MEMO TO: Neil Trotter, KCDC (cc Don Wignall, Transport Futures)
FROM: David Wanty, Wanty Transportation Consultancy
SUBJECT: SIDRA Airport Traffic Model review

ORIGINAL DATE: 7 & 11 Nov. 2016 REVISED: 28 November

This memorandum has been quickly prepared relating to a review of the SATURN/SIDRA traffic modelling methodology for the Paraparaumu Airport Zone and proposed District Plan and Plan Change activities

Figure 1: SIDRA Airport Model notation and example Level of Service output

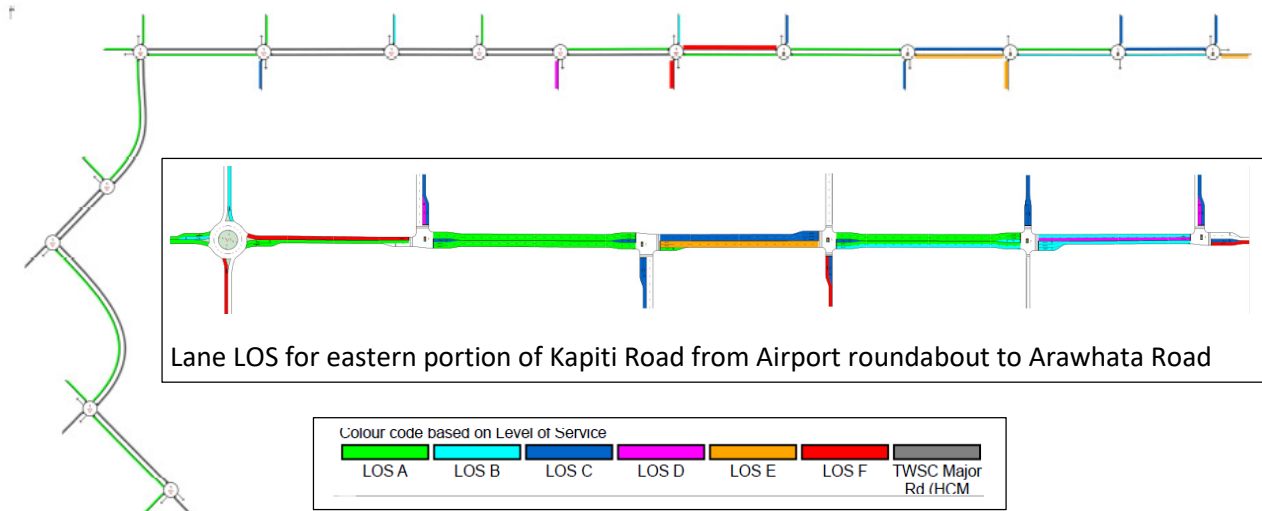
The network did not include the left in only access (from Kapiti Road southeast approach) to Mega Mitre 10 but this is considered acceptable. Unfortunately every site had the default site ID of 1, suggesting that the creation of the models was done in a very tight timeframe.

Figure 2: Westbound coordination for provided file (70s cycle) and example modified file (125s cycle)

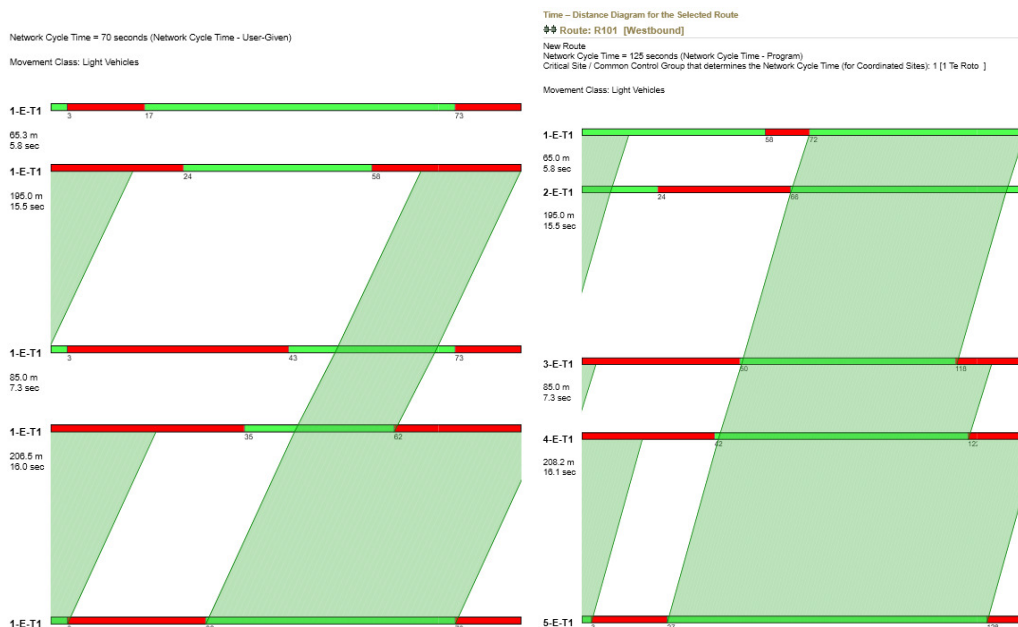
SIDRA 6.1 did not allow routes to be created to allow signal timing and coordination to be easily seen. Examination of the results for 2021 102.9k GFA revealed poor westbound coordination as modelled but which could potentially be significantly improved.

Figure 3: Westbound (left diagram) and eastbound (right diagram) coordination for 2017 with 23k GFA

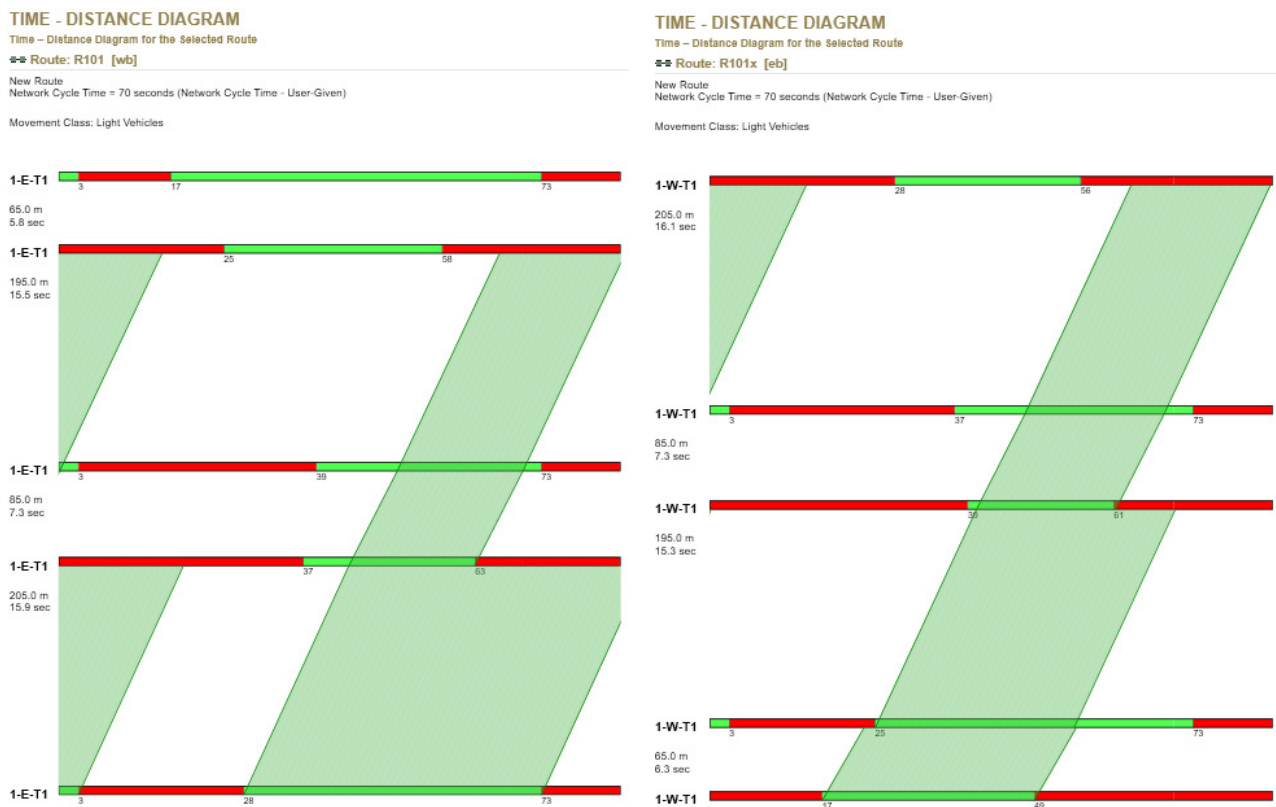
The Te Roto Drive intersection was modelled with only a single shared left/through (LT) lane whereas there is also a through short lane and a right turn short lane and three exit lanes to Milne Drive. The pedestrian crossing distances are set by default to program using the lane and median widths (there is also a median) and so this might affect the Te Roto phase time (it is preferable to input the pedestrian crossing distances). The Milne Drive intersection was also modelled with a short left, through and through lane whereas it is a full shared left/through, though and short through lane with three exit lanes to Te Roto Drive. These appear to be the critical intersections the study area and so they should be correctly modelled in the first instance.

Figure 4: Revised layouts tested for Te Roto Drive and Milne Drive (40 m gap in between)

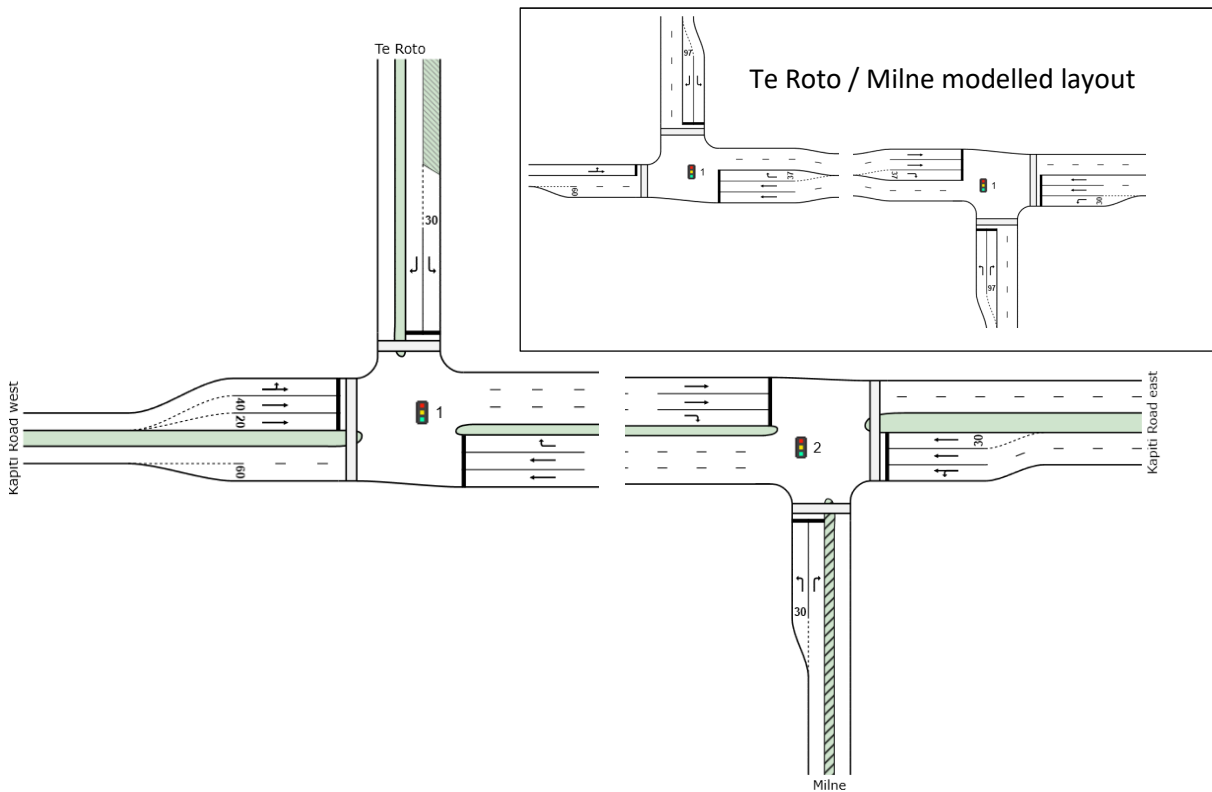
It is noted though that the intersection layout has been changing in recently; the KCDC aerials show the old layout with only one through lane in each direction between the Drives whereas at least the model had 3.

Figure 6: Observed turning flows from 4:35 – 5:35 pm (excludes the upstream left in only from the east)

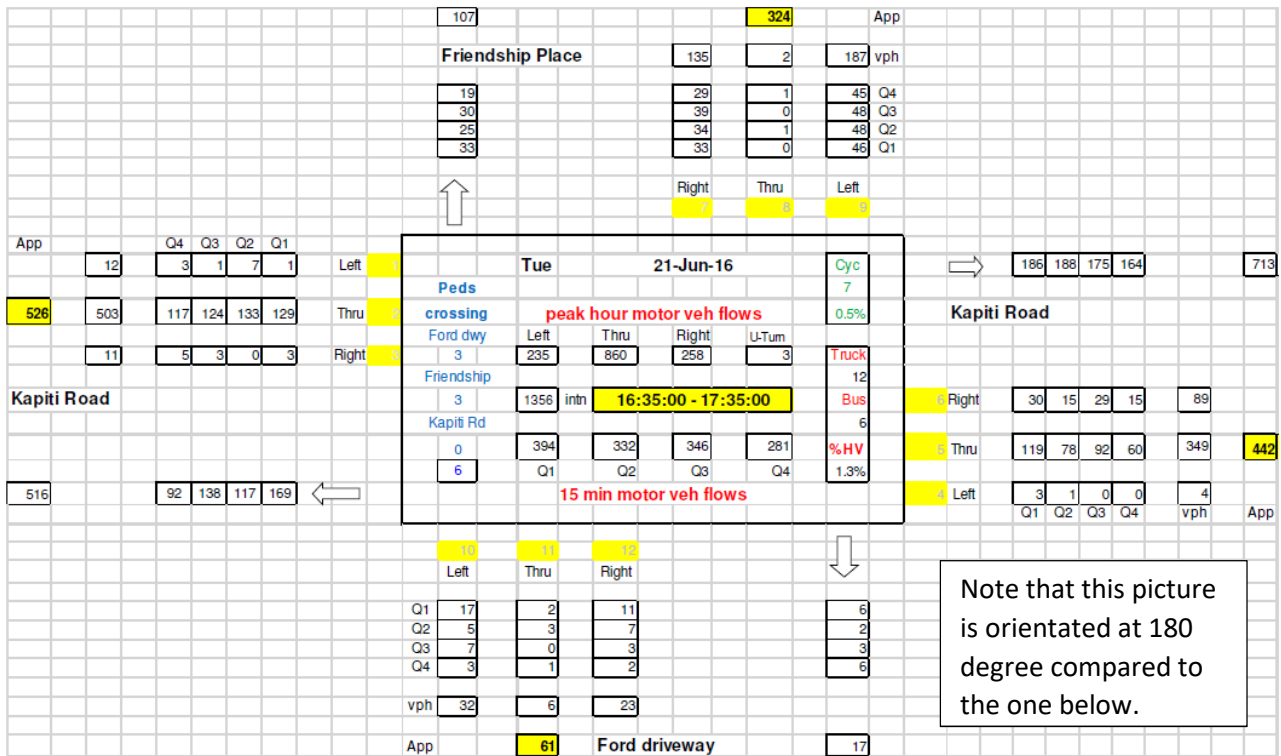
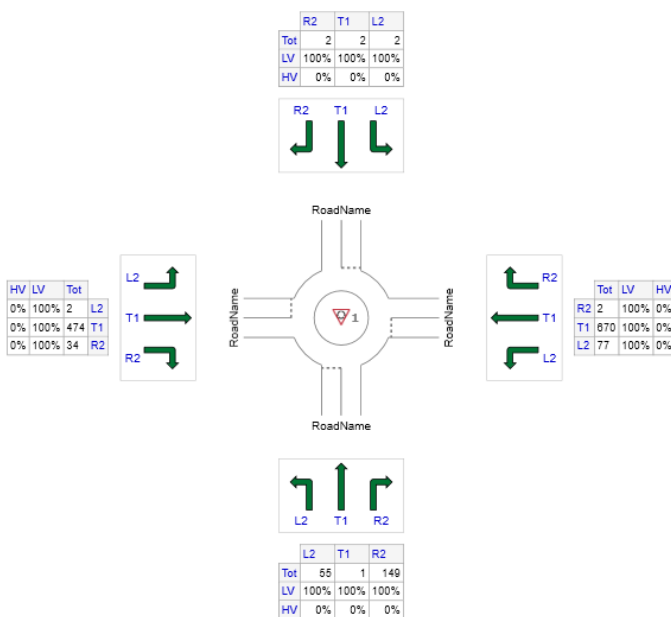
Comparison reveals that the modelled 2017 Kapiti Road flows are substantially higher, possibly suggesting that the existing development GFA is much less than 23,000 sqm (includes consented).

The model has far more traffic turning right out of Friendship Place than left, but the observed flows has more turning left. This however might be consistent with a high passby component not included in the modelled turns out.
